UNITED STATES PATENT AND TRADEMARK OFFICE

APPLICATION NO.	FILING DATE	FIRST NAMED INVENTOR	ATTORNEY DOCKET NO.	CONFIRMATION NO.
10/671,367	09/24/2003	Mark W. Kroll	A03P1066	1862

Office Action Summary	Application No. 10/671,367	Applicant(s) KROLL ET AL.	
	Examiner Kennedy Schaetzle	Art Unit 3766

DETAILED ACTION

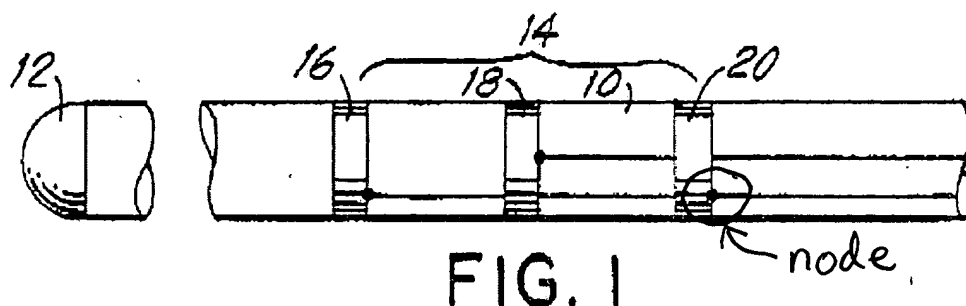
Regarding claim 9, the examiner considers the point circled below to be a node point.
